Addendum No. 1

Project: Smith Field Airport
Construct T-Hangar
Project No – SMD 25-01

Date: August 28, 2025

Section SP – Special ProvisionsItem MST-01, T-Hangar Building

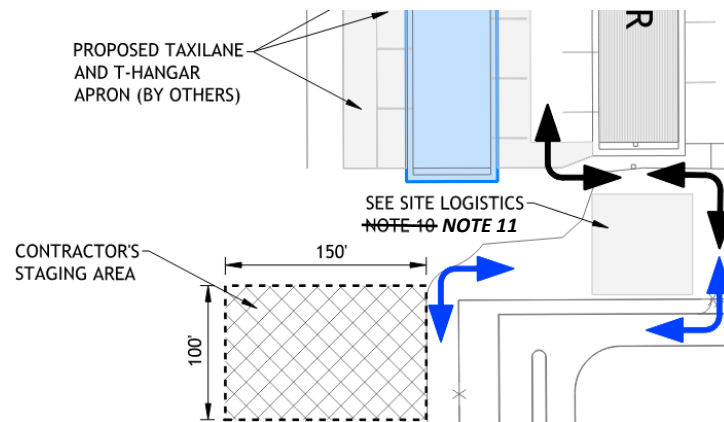
Revision: Section 01-1.1 (8) has been revised to read as following:
 Inside wall partitions shall be ~~29 gage galvalume~~ **26 gage galvalume** coating and allow for each unit to be completely enclosed so that access from one hangar unit to the next is restricted and bird proof.
